Former Newsome Bowling Club St Johns Avenue, NewsomeSt John Avenue, Newsome

Stage 1 Road Safety Audit

CLIENT:	Saleem Akhtari
PROJECT TITLE:	Former Newsome Bowling Club
	St John Avenue, Newsome
REPORT TITLE:	Stage 1 Road Safety Audit
PROJECT REFERENCE:	154080
DOCUMENT NUMBER:	001
ISSUE NUMBER:	01
DATE:	April 2023

Marked Up Plan for the Stage 1 RSA

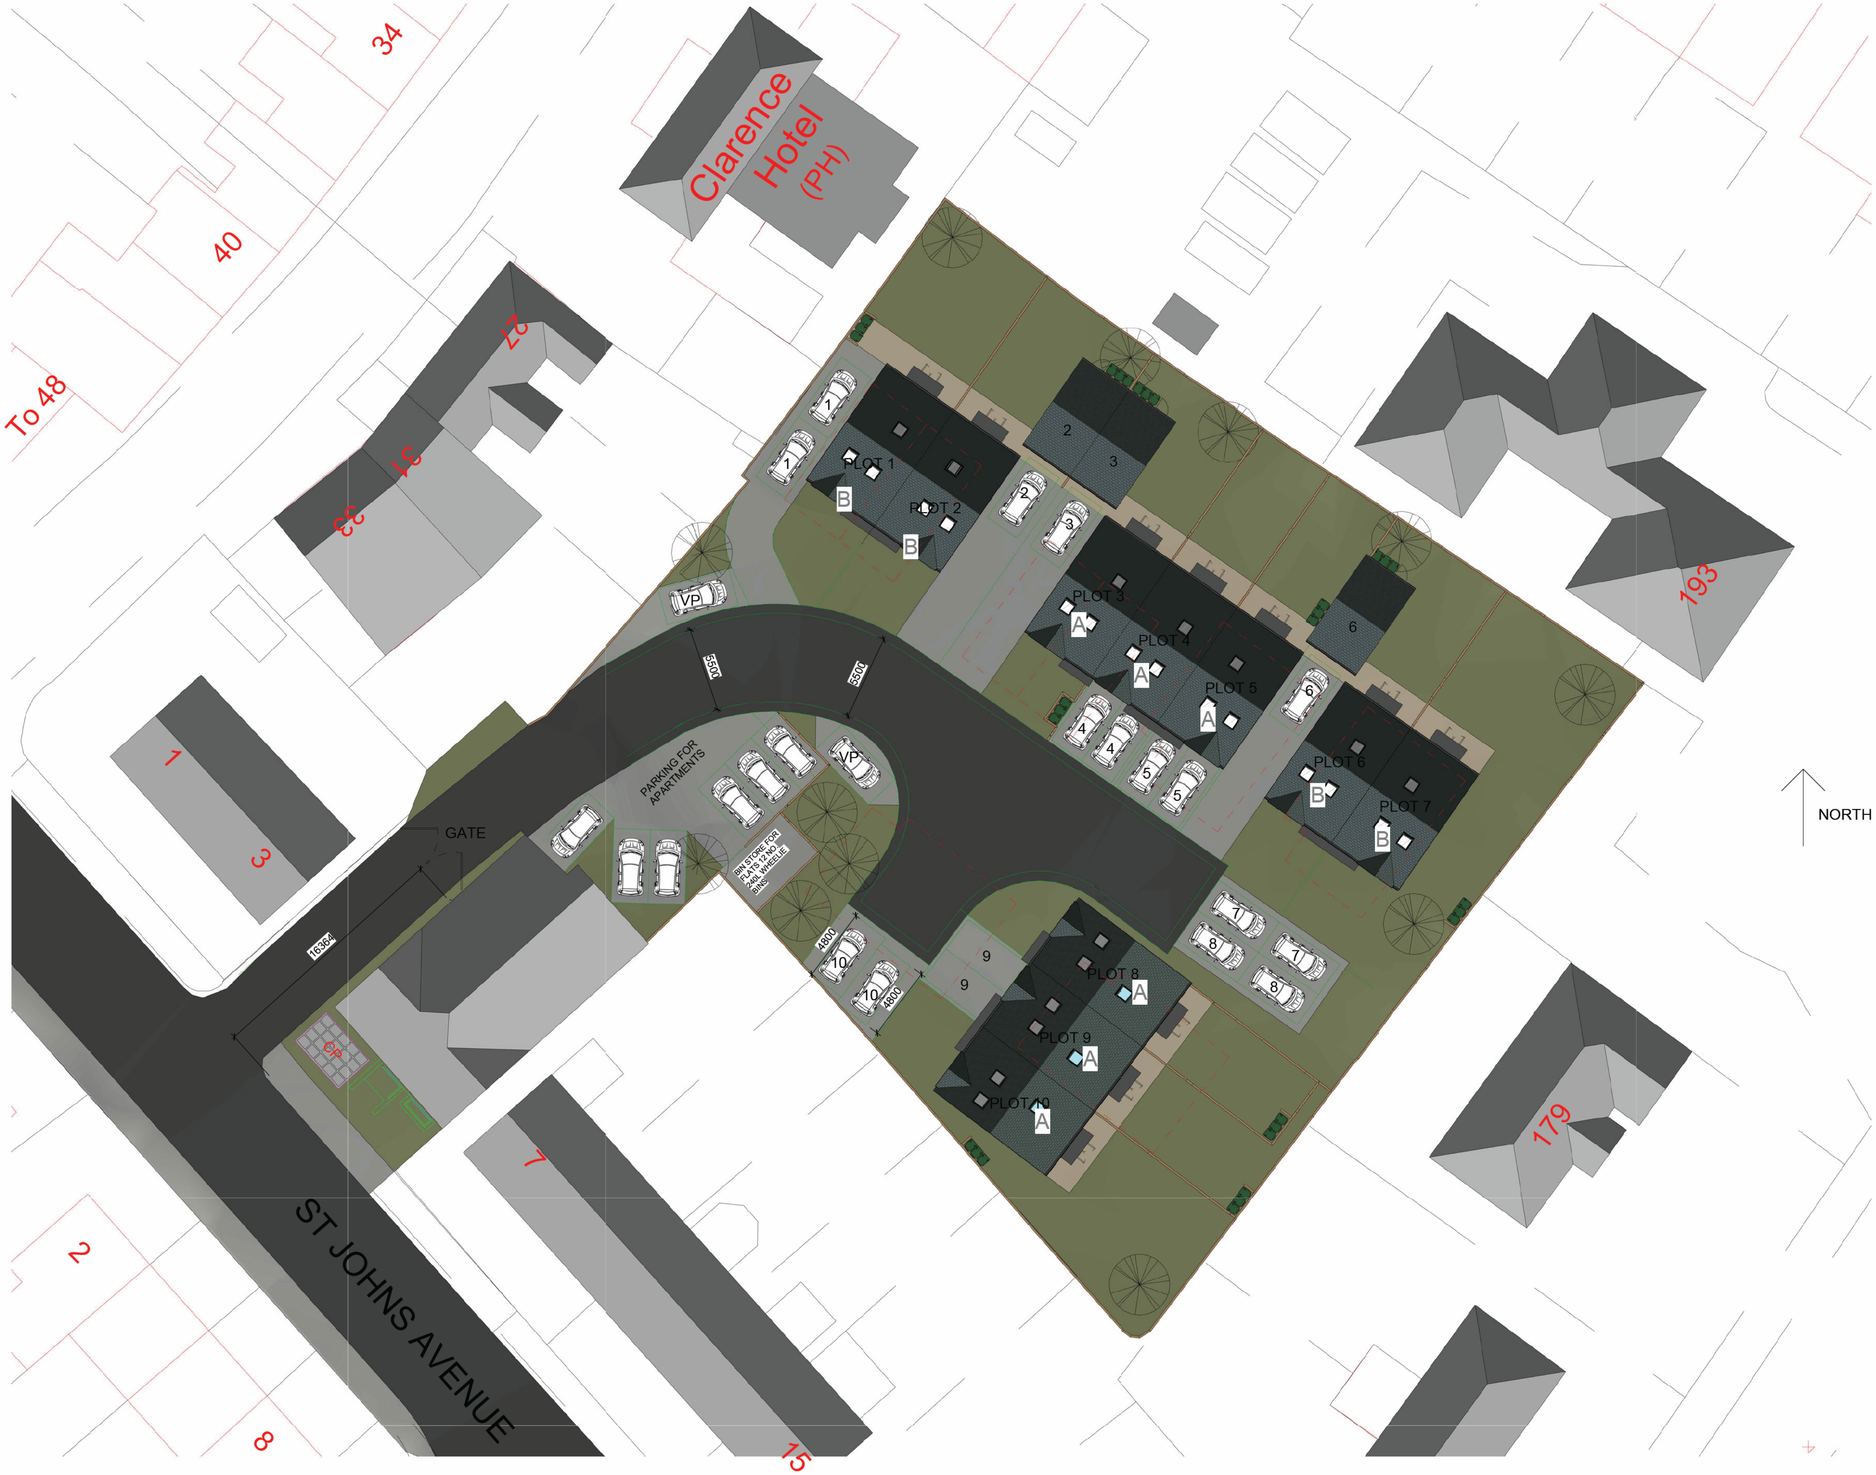
Location: Proposed access to St Johns Avenue.

Summary: The existing access is provided with small radius kerbs into the site with a dropped kerb on the south east side. No dropped kerbs are provided on the north western side and no tactile paving are provided. Furthermore, the surfacing to the existing vehicle footway crossing point is in a poor condition and there is a service cover in the crossover. No details about proposed kerbing, surfacing, levels or drainage have been provided at this stage but appropriate surfacing, levels (and / or drainage) should be provided to prevent surface water run-off on to the vehicle crossover area. Inadequate surfacing, drainage and levels could lead to pedestrian slip and trip hazards during inclement weather conditions as pedestrians cross the access.

Location: Proposed access to St Johns Avenue.

Summary: The existing access is provided with small radius kerbs into the site with a dropped kerb on the south east side. No dropped kerbs are provided on the north western side and no tactile paving are provided. No details about proposed kerbing have been provided at this stage. It is noted that the amount of vehicular activity accessing the proposed houses will increase and inadequate dropped kerbs and warning to pedestrians of the access could lead to pedestrian slip and trip hazards as they cross in front of the access road or conflicts between vehicles and pedestrians.

Recommendation: Provide appropriate surfacing, levels and drainage for the footway crossover area with service covers adjusted to correct levels.

Recommendation: Provide appropriate dropped kerbs and tactile paving for pedestrians either side of the access road carriageway.
